CERTIFICATE OF APPROPRIATENESS PLACARD

223 ELM STREET

119-15-MW

Raleigh Historic Development Commission – Certificate of Appropriateness (COA) Application

HORIZONTAL SECTION

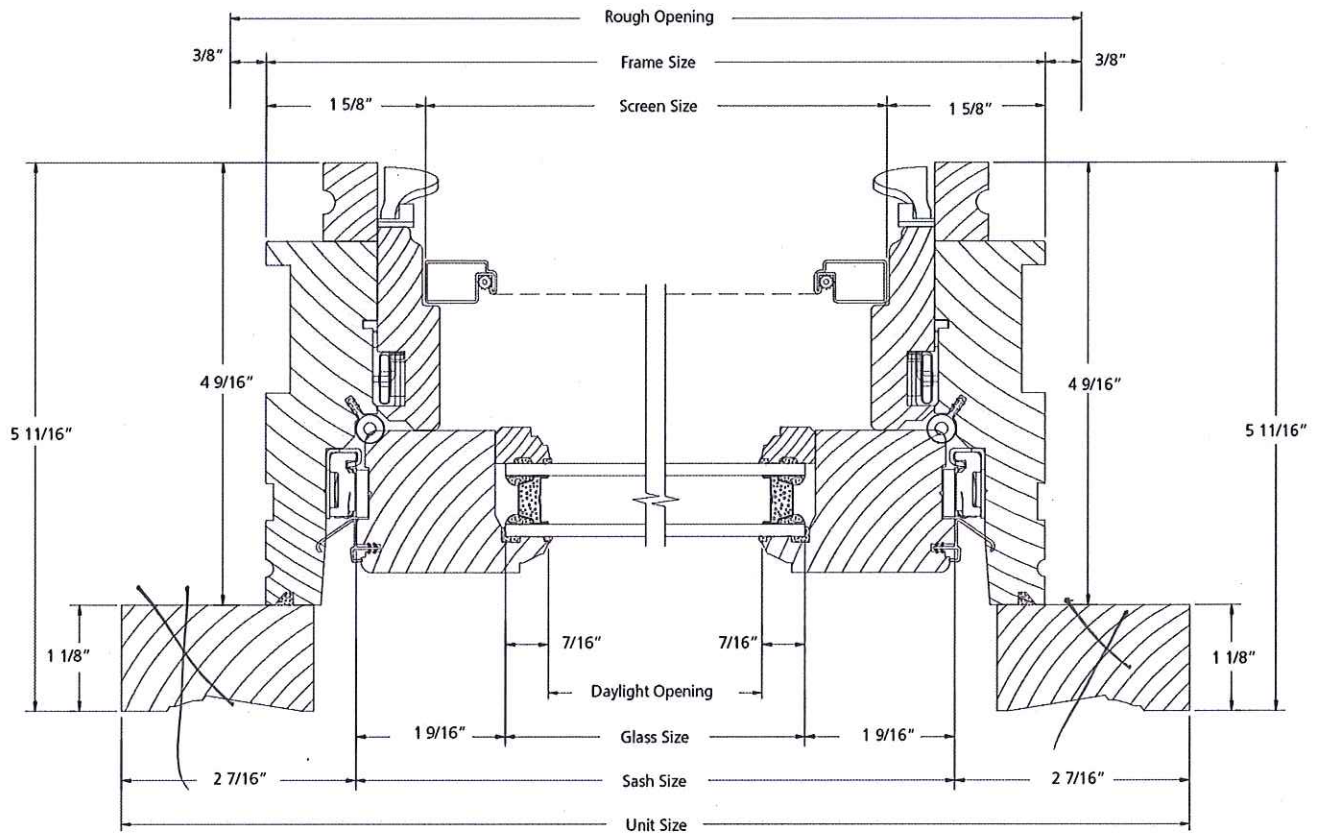
1. There is a note that trim will match existing. Please provide close up photo of trim being matched. Please also provide muntin specifications/sections.

Trim will be built onsite to match existing
